ECR/Documents for Information and Approval

Giulia Romagnoli and Natalya Kahn for BE-EA, 2024-11-26

New Motorized Support for XEMC in PPE128 on H8 Beamline

New Buffer Zone in BA8₁

Figure 4 – New XEMC support in position IN.

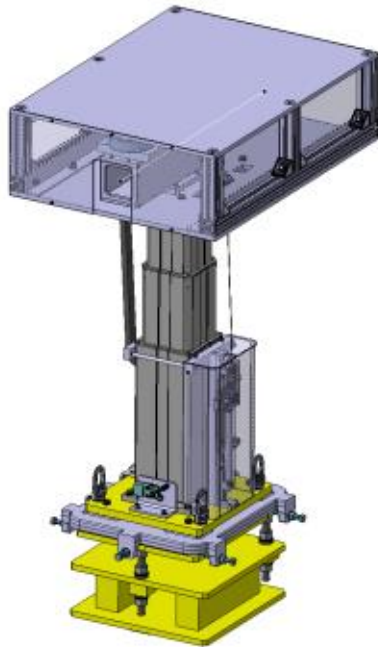
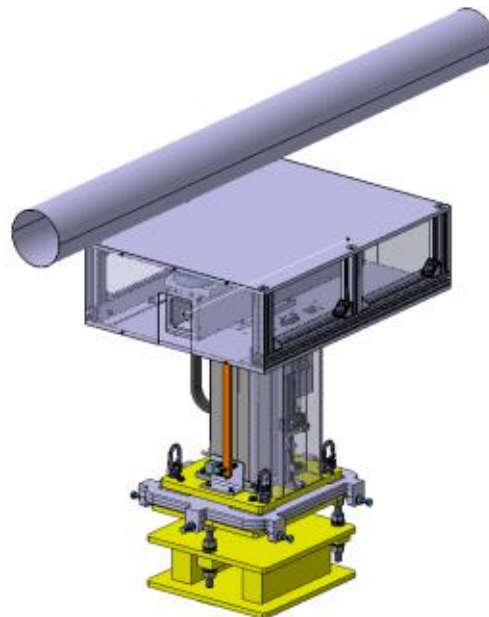
Seen by AHDIDA Claudia Christina (HSE-RP)	Creator
Seen	
Seen by VAXELAIRE Didier (EN-AA)	Creator
Accepted by FOLCH Ramon (BE-EA)	Creator
Seen by FUMEY Sylvain (EN-HE)	Creator
ok	
Seen by GENILLON Xavier (SY-EPC)	Creator
Seen	
Accepted by KAMENICKA Eva (BE-EA)	Creator
All comments from ENG check have been considered. The precision of XEMC is defined as +/- 0.5 mm. The link to HXEMC drawings and to EAM item is now added to the document. The equipment need to be traced on ground on site. The anti-collision switch has already been part of the design before (see chapter 6). A paragraph about transport has been added (see chapter 3 and figure 6).	
Seen by VENDEUVRE Camille (BE-GM)	Creator
Accepted by ORTEGA RUIZ Inaki (SY-BI)	Creator
All SY-BI control details have been defined in separate meetings. Replying to Maarten Van Dijk: the HV can be left on during movement, as in the other instruments.	
Seen by BEYNEL Alexandre (BE-GM)	Creator

Figure 3: Top view of proposed solution for the new buffer zone.

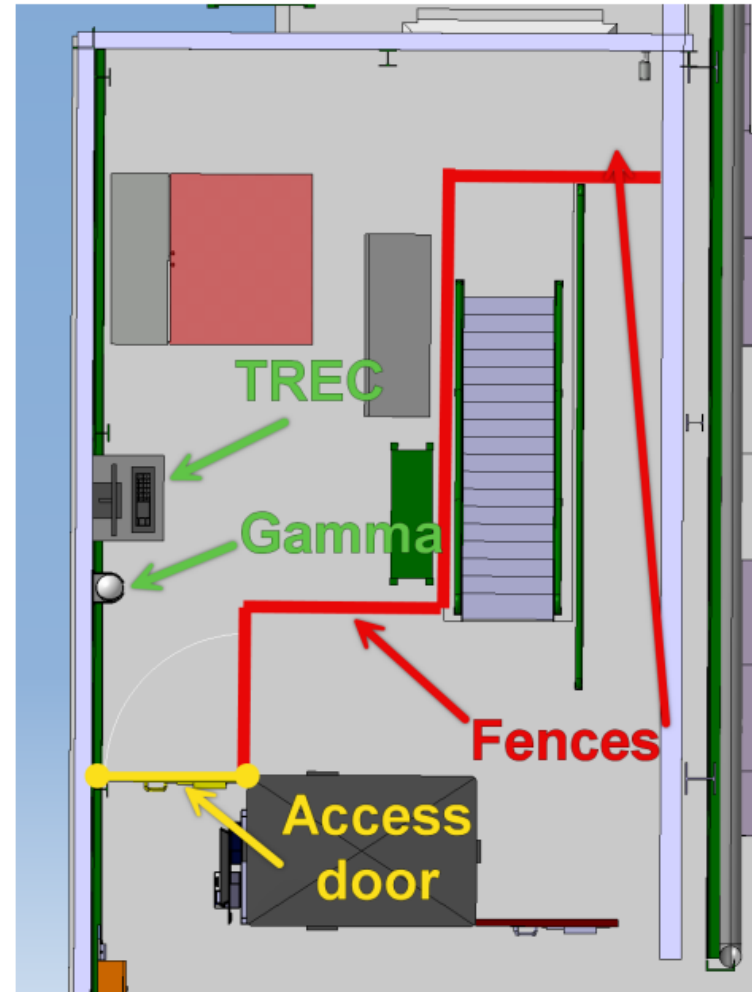
Ne serait il pas plus interessant de placer les équipements (Lecteur DMC, Dosimetre et ecran d'information) sur le mur extérieur plutôt que contre le PAD? L'alimentation et le reseau sont desservi depuis le mur extérieur.

Le passage va etre relativement étroit, en les placant sur le mur extérieur on peut gagner un peu d'espace en les logeant dans la structure métallique.

Merci beaucoup pour le document. Je pense que l'idée de Didier est bonne, d'autant plus que les lecteurs dosimètres et écrans seraient plus visibles!

Asset Replacement Request - BSPl.04576g

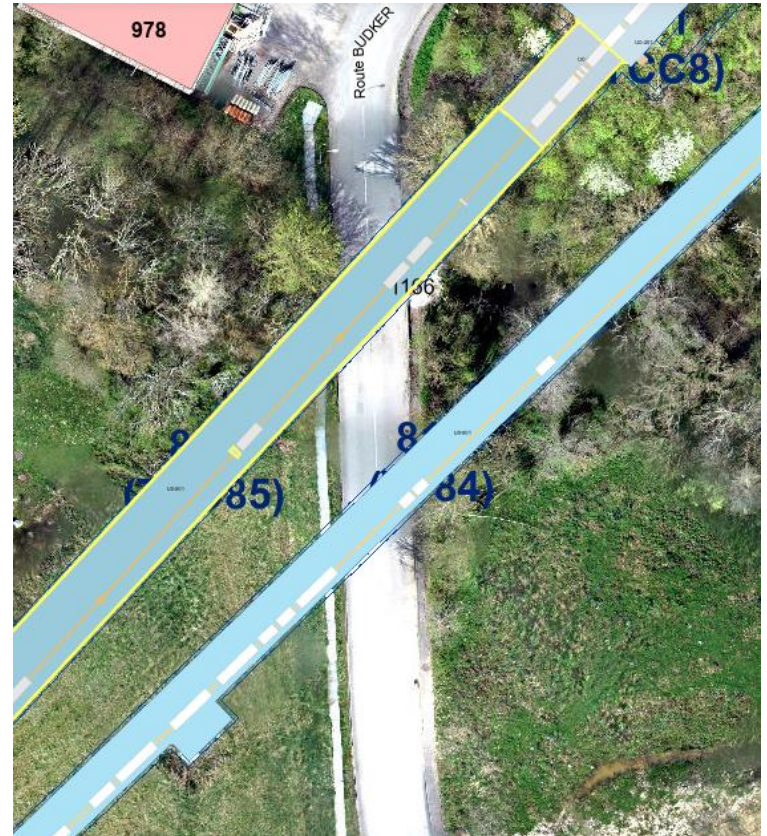
Functional position does not correspond to layout one
Asset IDs are functional positions so we don't know if the full tank is changed or only the instrumentation.

Please provide more details about the change.
Please add also a valuable functional position and ASSETS numbers.
